Technical Service Bulletin

Subject: ABNORMAL NOISE WHEN OPENING POWER LIFTGATE	Bulletin No.: 09-006/26
	Last Issued : 01/26/2026

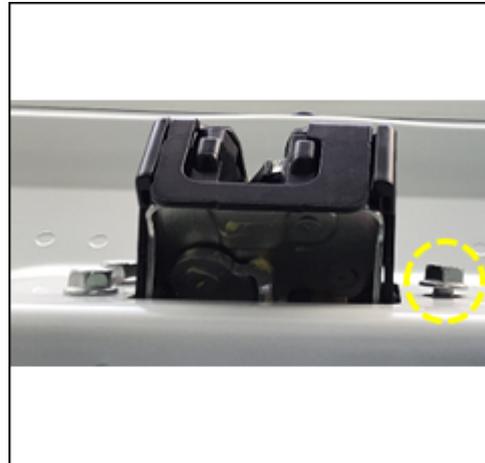
Some customers may report hearing an unusual noise coming from the power liftgate (PLG) when it is unlatching to open or latching closed. This is caused by an internal fault in the liftgate latch and/or loose bolts holding the latch to the liftgate. To eliminate this concern, the internal structure of the latch and surface treatment of the bolts have been modified.

NOTE: This Service Information is only applicable if the liftgate latch has the following conditions:

The latch bracket is damaged

The bolt is loose

1. Verify the customer concern.
2. Replace the latch and bolts with the improved parts listed in the parts section following the instructions in MGSS:
 - **CX-30: LIFTGATE LATCH AND LOCK ACTUATOR REMOVAL/INSTALLATION**
 - **CX-50: LIFTGATE LATCH AND LOCK ACTUATOR REMOVAL/INSTALLATION**
3. Verify the repair by confirming the noise has been eliminated.

Part Number	Description	Qty.	Notes
DGJ1-62-310A	LOCK, LIFTGATE	1	Applicable to CX-30 & CX-50
9KGB-E0-616	BOLT	4	DO NOT use bolt 9946-60-616 which is listed in GEPC.
